Pentium® Processor Specification Update

Release Date: November 1998

Order Number 242480-039

1. ***Pentium® Processor's Response to Startup and Init IPIs***

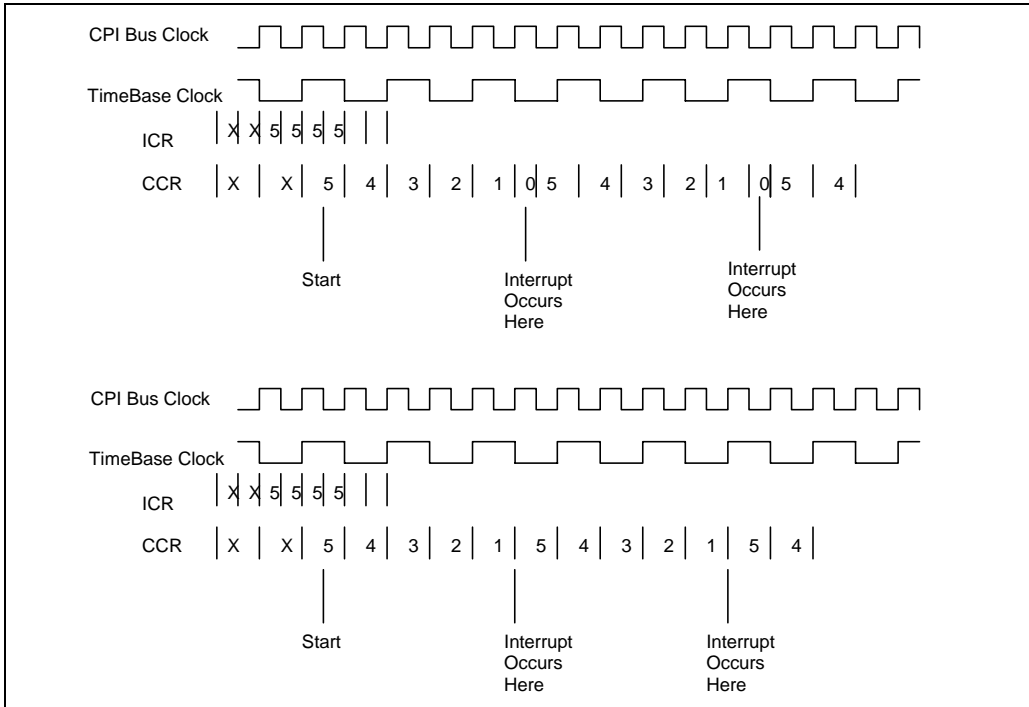
BSP sends AP an INIT IPI
BSP DELAYS (10mSec)
If (APIC VERSION is not an 82489DX)
{
    BSP sends AP a STARTUP IPI
    BSP DELAYS (200uSec)
    BSP sends AP a STARTUP IPI
    BSP DELAYS (200uSec)
}
BSP verifies synchronization with executing AP

Figure14-1. Maximum Undershoot Level, Undershoot Threshold Level, and Undershoot Threshold Duration

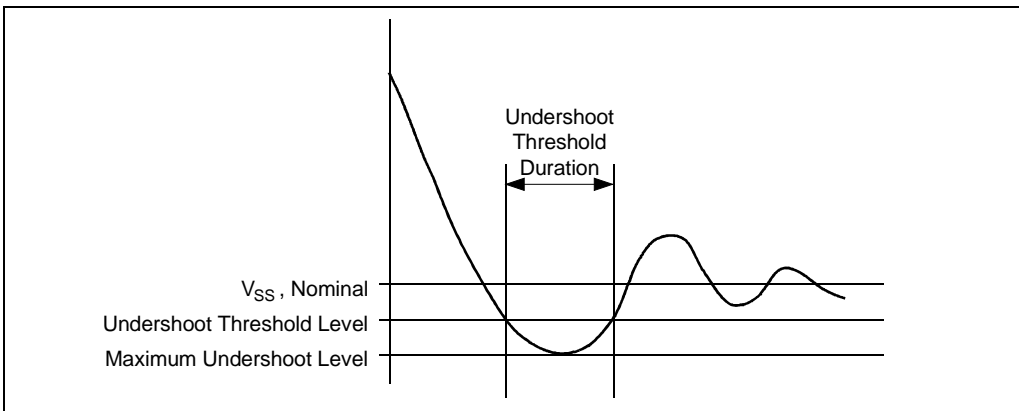
MAXIMUM RINGBACK SPECIFICATION: The maximum ringback of CLK associated with its low state (undershoot) must not exceed 0.8V as shown in Figure 14-1.

MAXIMUM UNDERSHOOT AND MAXIMUM RINGBACK SPECIFICATIONS: The display should show continuous sampling (e.g., infinite persistence) of the waveform at 500 mV/div and 5 ns/div (for CLK) for a recommended duration of approximately five seconds. Adjust the vertical position to measure the maximum undershoot and associated ringback. There is no allowance for crossing the maximum undershoot or maximum ringback specifications.

UNDERSHOOT THRESHOLD DURATION SPECIFICATION: A snapshot of the clock signal should be taken at 500 mV/div and 500 pS/div (for CLK). Adjust the vertical position and horizontal offset position to view the threshold duration. The undershoot threshold duration is defined as the sum of all time during which the clock signal is below -0.5V within a single clock period. The undershoot threshold duration must not exceed 20% of the period.
